Well Name	Well Number	US Well Number	Lease Number	Case Number	Operator
MORGAN 25-13	737H	3001555591	NMLC062300	NMLC062300	DEVON
MORGAN 25-13	627H	3001555589	NMLC062300	NMLC062300	DEVON

Type of Action: APD Change

Procedure Description: Devon Energy Production Co., L.P. (Devon) respectfully requests a change to the drilling plan for the Morgan 25-13 Fed Com 627H and 737H to include break test variance with stump testing . Attachment included.

PECOS DISTRICT DRILLING CONDITIONS OF APPROVAL

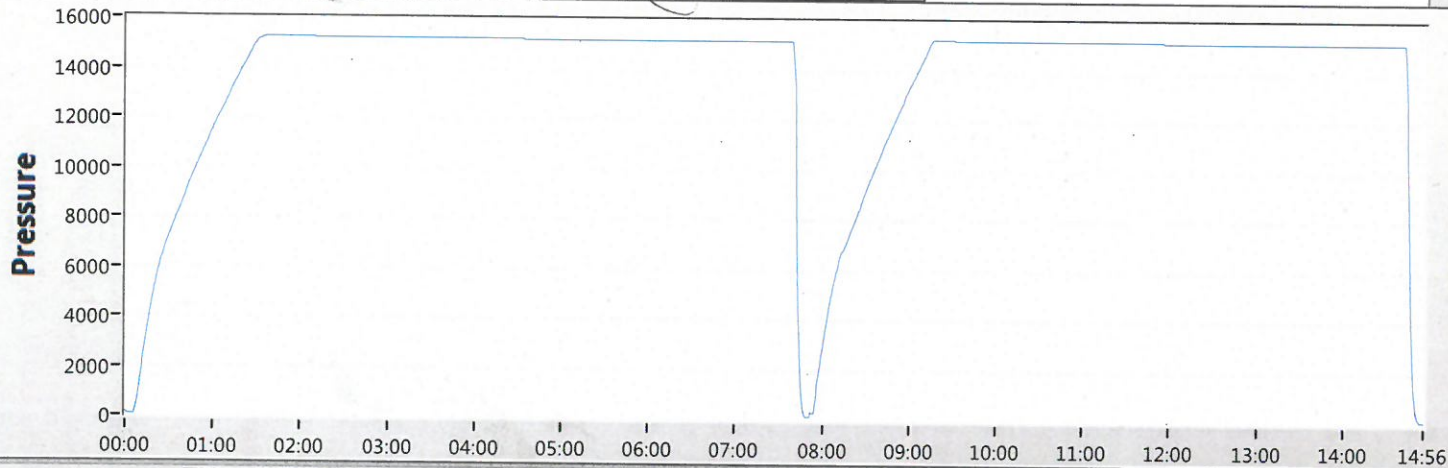
Devon Energy requests to perform offline BOP stump testing and offline BOPE testing. All pressure-containing and pressure-controlling seals will be tested either online or offline as denoted in the table below and per BLM approval during initial BOP test following test pressure requirements set forth in 43 CFR 3172. Remaining components not tested offline or on the stump will be tested within 72-hours when the BOP is connected to the wellhead. If stump testing exceeds 72-hour window prior to connecting to the wellhead, the BLM will be notified and either stump testing restarted, or the BOP being tested online. The BLM will be contacted 4hrs prior to a BOPE test. The BLM will be notified if and when a well control event is encountered. In the event stump testing is not utilized, then a full BOPE test would be conducted.

Components	Offline	Offline, BOPE	Break	Online
Upper Rams		X	X	X
Blind Rams		X		X
Lower Rams				X
Outside Kill Valve		X	X	X
Inside Kill Valve		X	X	X
Kill Line Check Valve		X	X	X
Inside Choke Valve		X	X	X
HCR		X	X	X
Kill Line	X			X
Annular		X		X
Choke Manifold Valves and Hose	X			X
Mudline (Mud Pumps, Rig Floor Valves, Kelly Hose, Mud Line)	X			X
Standpipe Valve	X			X
IBOP (Upper and Lower)	X			X

Devon requests offline BOPE testing for the following components: Upper Rams, Blind Rams, Kill Valves, Choke Valves, and Annular
